UNITED STATES PATENT AND TRADEMARK OFFICE

APPLICATION NO.	FILING DATE	FIRST NAMED INVENTOR	ATTORNEY DOCKET NO.	CONFIRMATION NO.
09/935,337	08/23/2001	Karl-Heinz Krah	41110	8132

Office Action Summary

DETAILED ACTION

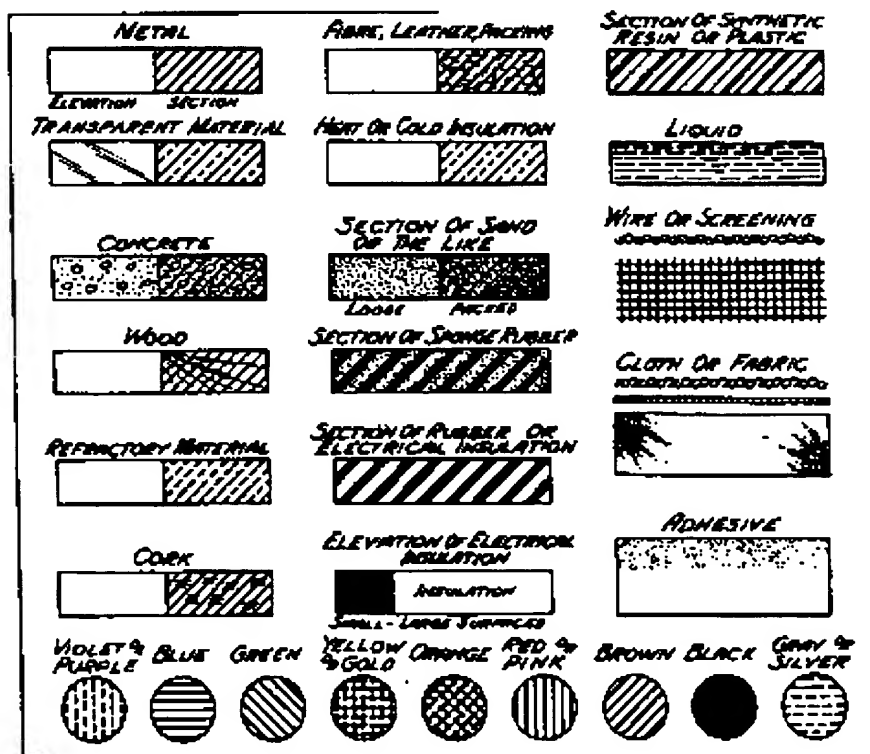
The drawings are objected to because of the following informalities:

Fig. 1-3, 5-8, 10-16: Proper cross-sectional hatching is required to properly denote plastic materials in accordance with MPEP 608.02 (see the drawing below for proper hatching examples).

The response to this action must include a separate letter addressed to the examiner and contain: (1) sketches showing *in red* the drawing changes required above and (2) a request that the examiner approve the changes as shown on the sketches.
